Appendix C2. U.S. Environmental Protection Agency Comment Matrix

Air Quality Technical Report

US 60 (Grand Avenue)/35th Avenue/Indian School Road Traffic Intersection Improvements Maricopa County, Arizona

Project Name:	US60 Grand Avenue/Indian School Road Traffic Interchange	Name: Michael Dorantes	COMMENT RESOLUTION
Project Number(s):	ADOT Project No. 060 MA 159 F0272 01C	Agency: EPA	
Document Name:	Interagency Consultation Document		
Document Date:	September 2023		
			For ADOT USE

Figure 3. Indian School Road/33rd Avenue Intersection Configuration – No Build Alternative

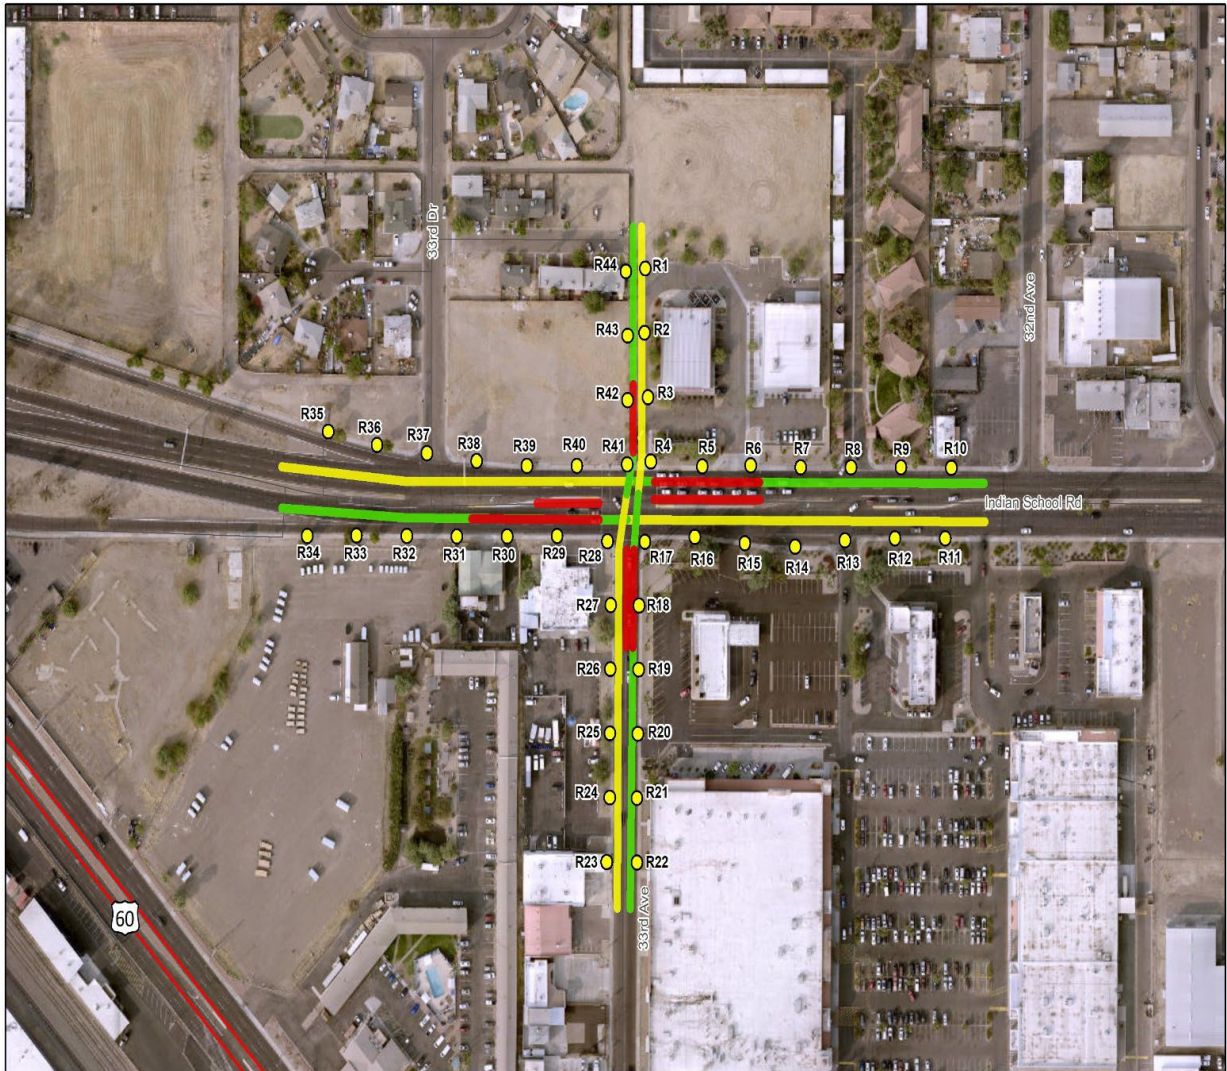
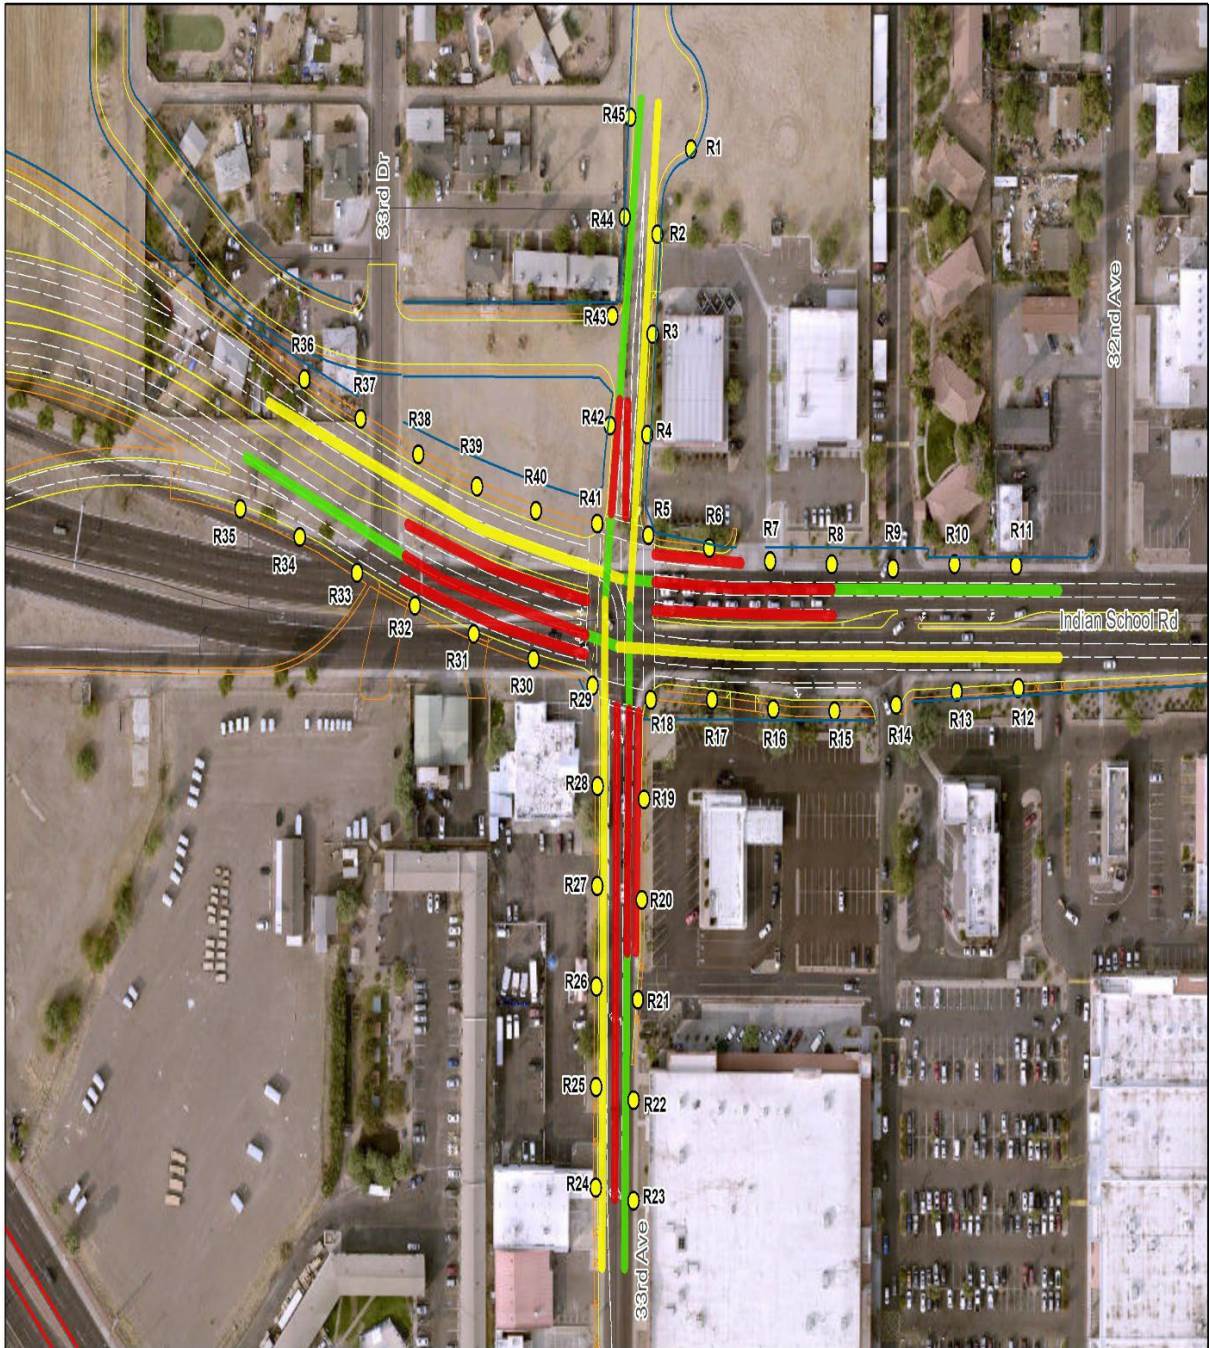
- Receptor placement:
 - Figures 3 and 4 show the intersection configuration. There is a sidewalk along the intersection of 33rd Ave and Indian School, and this is where we placed the receptors. These locations capture where we could expect to find the highest concentrations.

- EPA noted they are seeking clarification on where the receptors were placed. The receptors go out to mid-block and beyond, which is what they are looking for. EPA doesn't see the need to change anything in the model in this location.

15		4		<p>Receptor Locations: Although the description here is consistent with the guidance, please provide more exact detail regarding the receptor placement in the “Select Air Quality Model, Data Inputs, and Receptors Using CAL3QHC” section on page 19. For example, are all receptors placed exactly 3 m away from the road? Are the receptors located up to mid-block in each direction, as recommended in the guidance?</p>	<p>As noted in Table 4 of the Modeling Assumptions document, receptors are typically located at locations where the general public has continuous access. Such locations include, for example, crosswalk locations, bus stops and sidewalks adjacent to the roadway. There are sidewalks on both Indian School Road and 33rd Avenue under Existing Conditions and under the 2050 Build Alternative. Model receptors were placed at the crosswalk locations and on sidewalks which are more representative of where the general public would have continuous access. Receptors are not placed exactly 3 meters from the road because the general public would be unlikely to have continuous access at such locations for extended periods of time. Receptors were placed at appropriate locations to capture the maximum CO concentration where the public would have continuous and extended access.</p> <p>Receptors are shown in Figure 3 and Figure 4 of the Modeling Assumptions document and extend more than 450 feet on each leg of the intersection. Additional text has been added under "Select Air Quality Model, Data Inputs, and Receptors Using CAL3QHC."</p>

Figure 5. West Phoenix CO Monitor Location

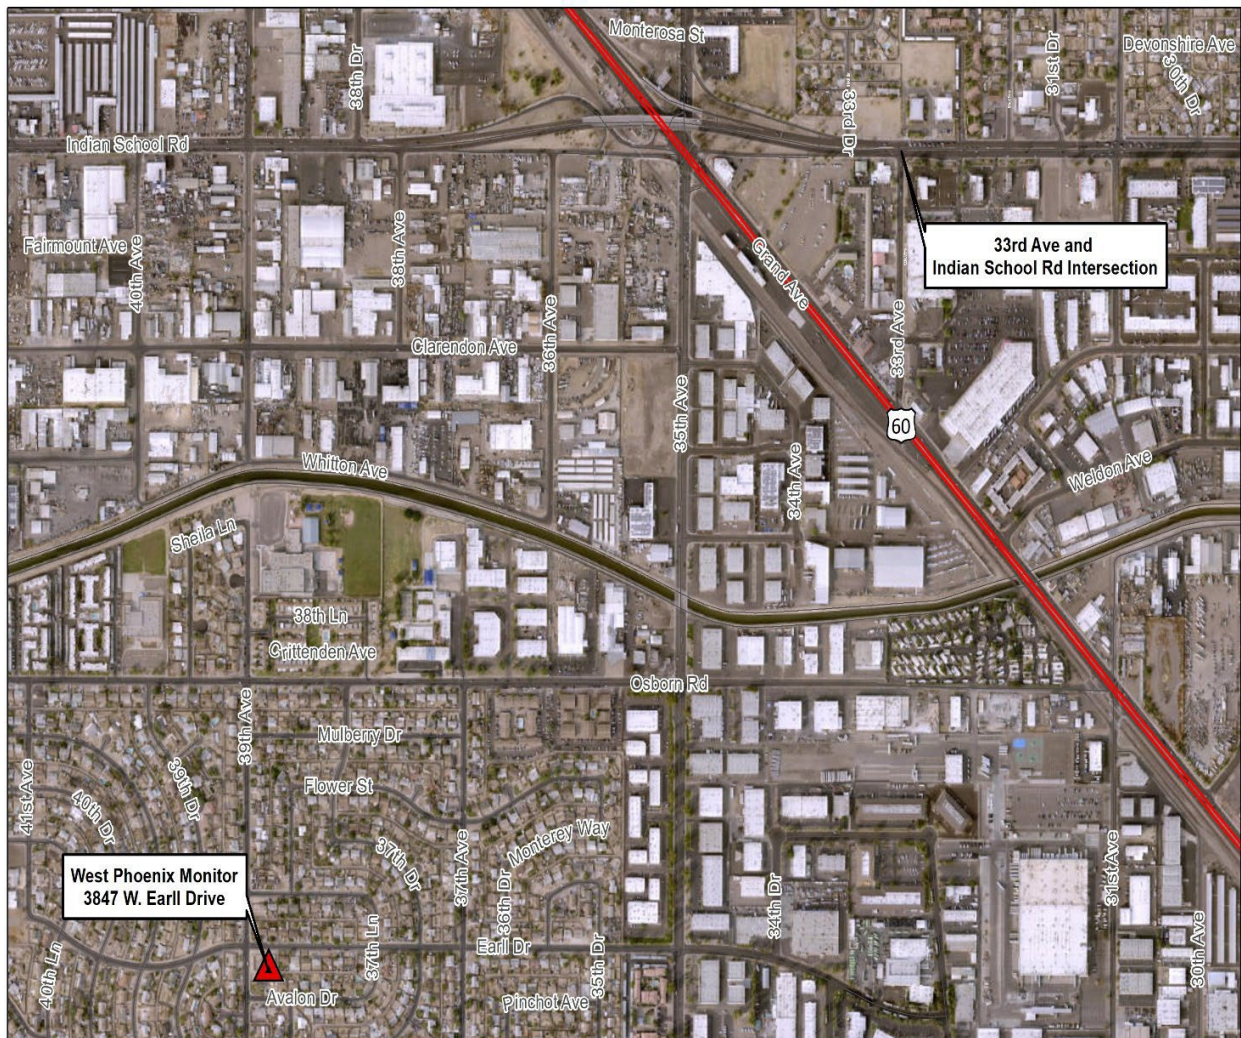
- *EPA suggested in the future provide details of characteristics of the background monitor shown and how it compares to the current project area, wind direction information. ADOT can update consultation to show visual map to show monitor location in relation to project area*
